# Design Enhancements Report Response to Refusal of 24/000062/FUL

79 Riddlesdown Road, Purley

9<sup>th</sup> August 2024

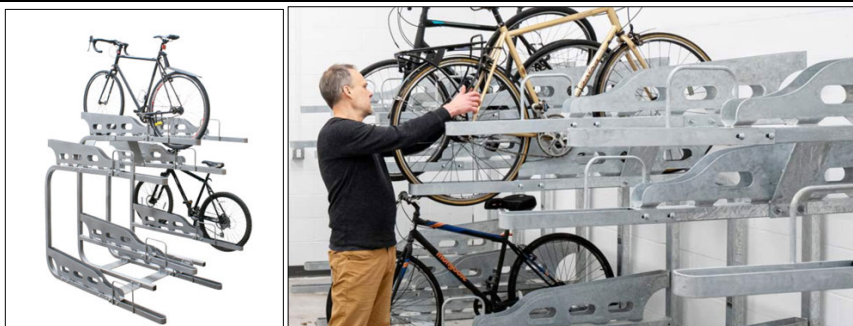
5.54	A lift is not provided on site. London Plan Policy D7 seeks that only in exception circumstances the provision of a lift may not be achievable in four storeys or less. The supporting documents have provided no evidence to suggest why a lift cannot be achieved within this particular development. Whilst the applicant has provided drawings suggesting that the scheme could deliver M4(3) accommodation, future occupiers would be expected to navigate a short and undesignated part of the forecourt between a refuse store and parking	Please refer to Section 2.2 of the report titled "DCR-001-00 - Design Compliance Report - Approved Document M" for a detailed rationale for excluding a lift installation.

Case Officer Report Number	Case Officer Commentary	Polaris Passivhaus Response + Design Enhancements
	space to a narrow alley. An external stairlift would then provide step free access to the unit on the lower ground floor level. This arrangement is completely inappropriate and unfit for potential disabled users of the site.
